MIL-M-28787/64A
AMENDMENT 3
31 December 1992
SUPERSEDING
AMENDMENT 2
14 August 1984

MILITARY SPECIFICATION

MODULES, STANDARD ELECTRONIC

GATE, AND-OR-INVERT, DIGITAL, KEY CODE LHJ

FIGURE 6. $V_{OUT}$ (low-loaded) test circuit for table IV.

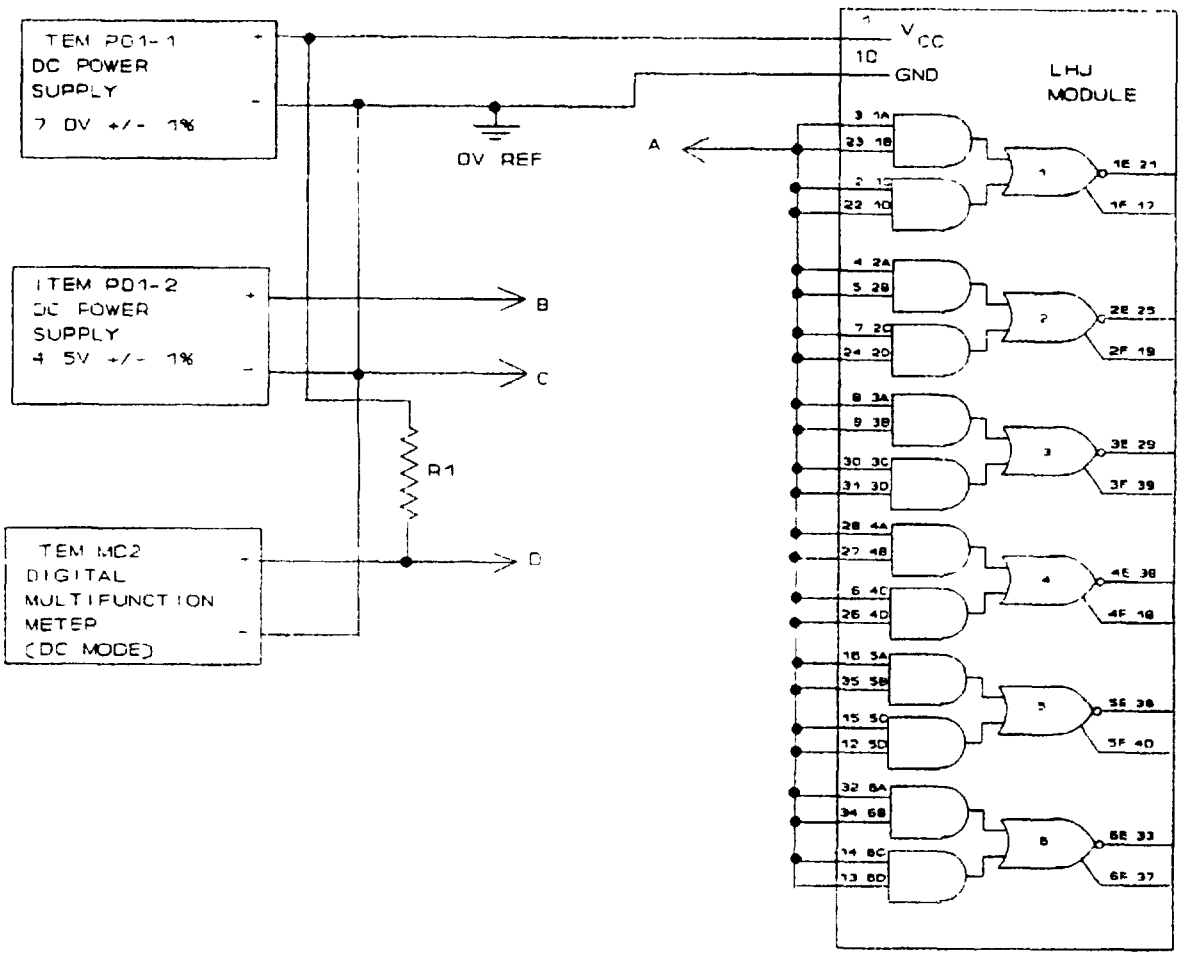
FIGURE 6: Delete and substitute new figure 6 as printed on page 4 of this amendment.

NOTE: R1 = 249Ω ± 1%, 1/4 W.

FIGURE 10. Input clamp diode voltage test circuit for table VIII.

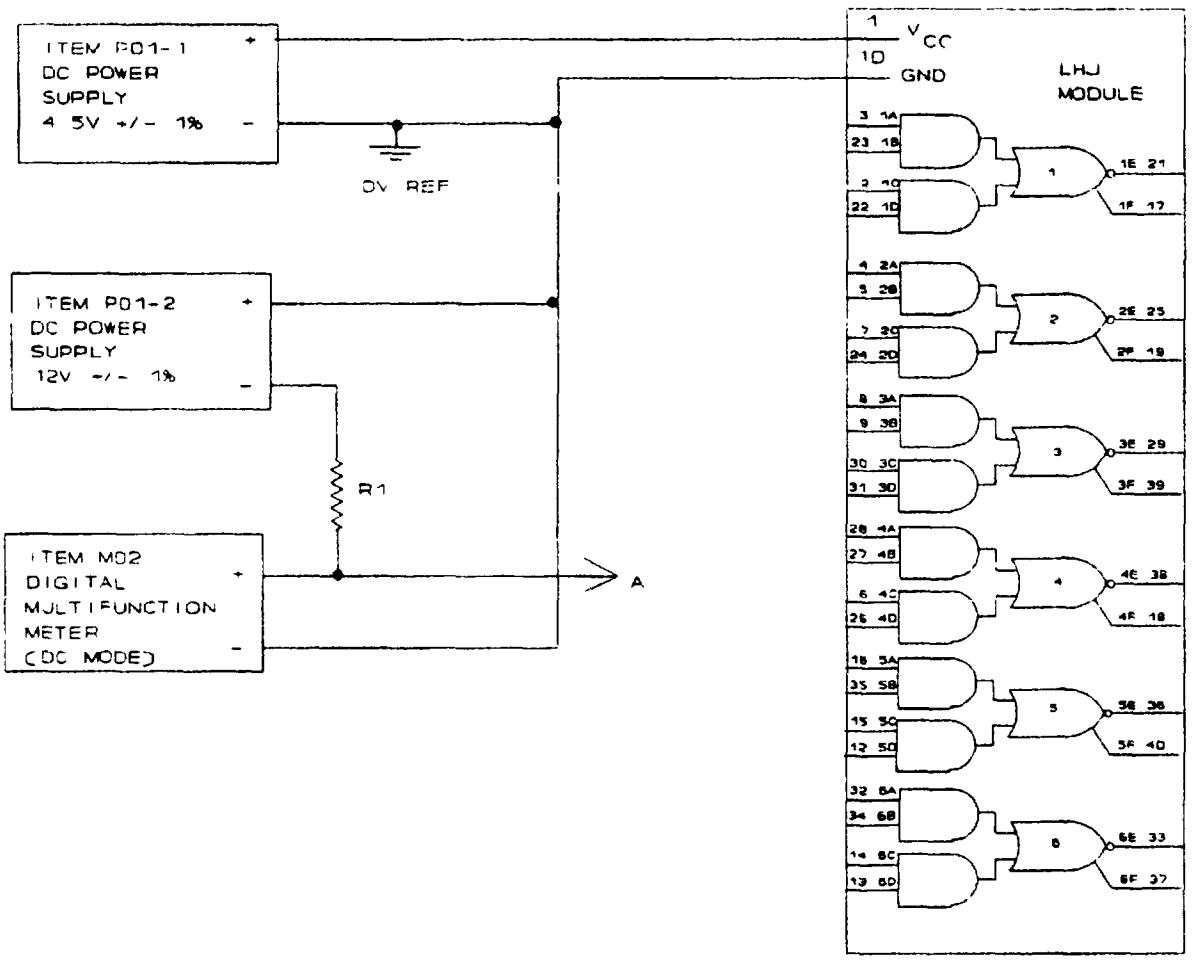
FIGURE 10: Delete and substitute new figure 10 as printed on page 5 of this amendment.

NOTE: R1 = 590Ω ± 1%, 1/4 W.

FIGURE 11. Static output voltage (high-level and low-level) test circuit for table IX.

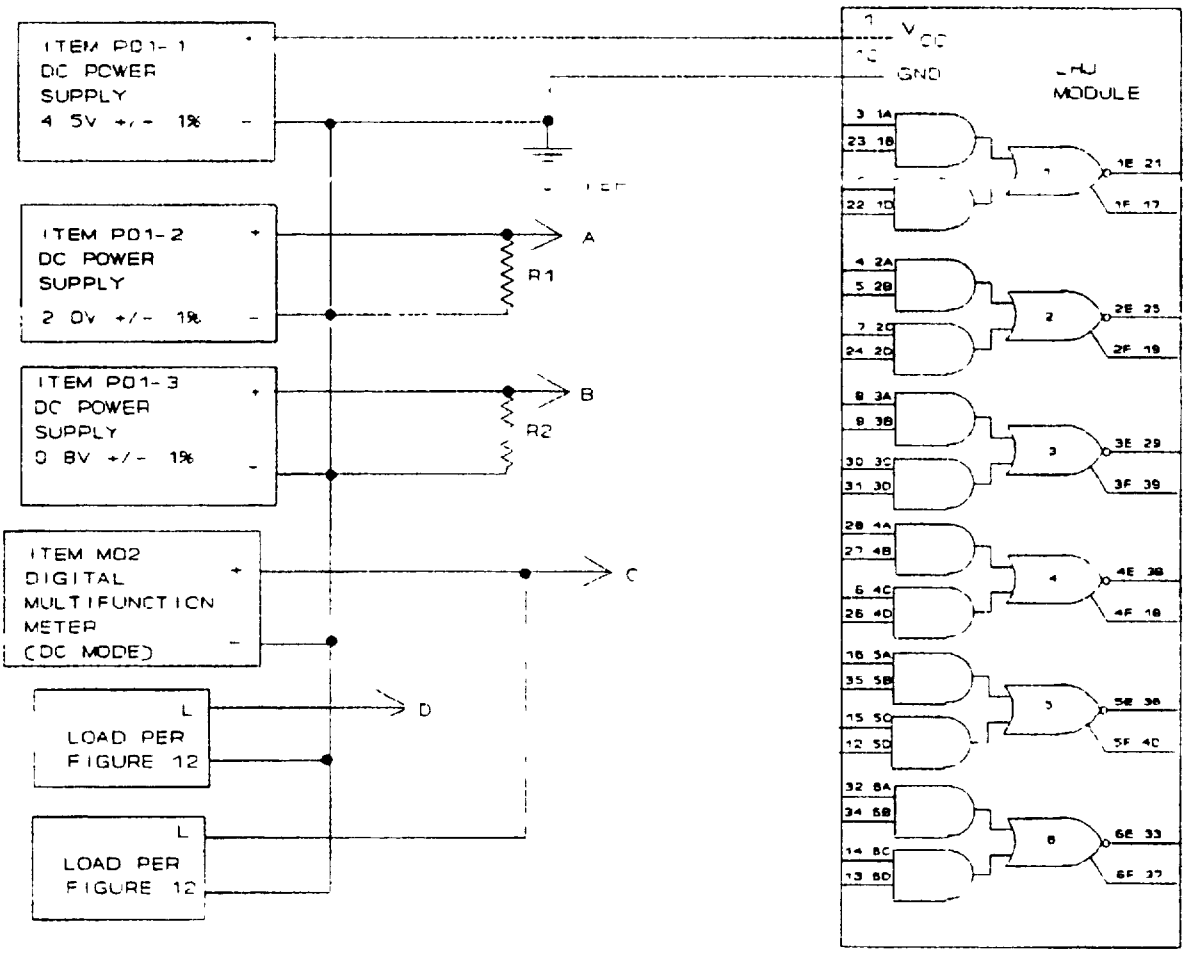
FIGURE 11: Delete and substitute new figure 11 as printed on page 6 of this amendment.

1. R1 = R2 = 51Ω ± 5%, 1/2 W.
2. Both outputs of the circuit under test shall be loaded simultaneously per figure 12.

FIGURE 13. Functional test circuit for table X.

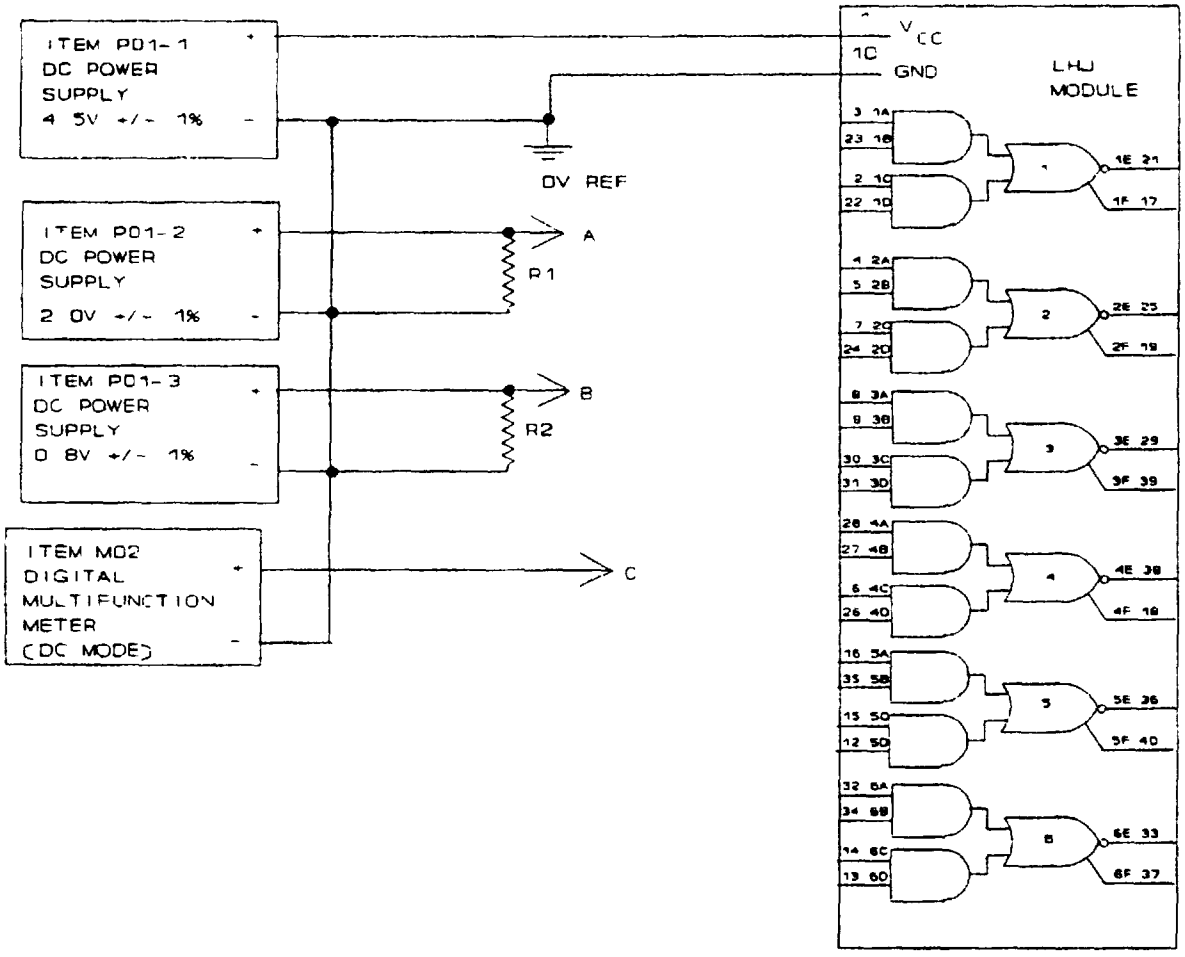
FIGURE 13: Delete and substitute new figure 13 as printed on page 7 of this amendment.

NOTE: R1 = R2 = 51Ω ± 5%, 1/2 W.
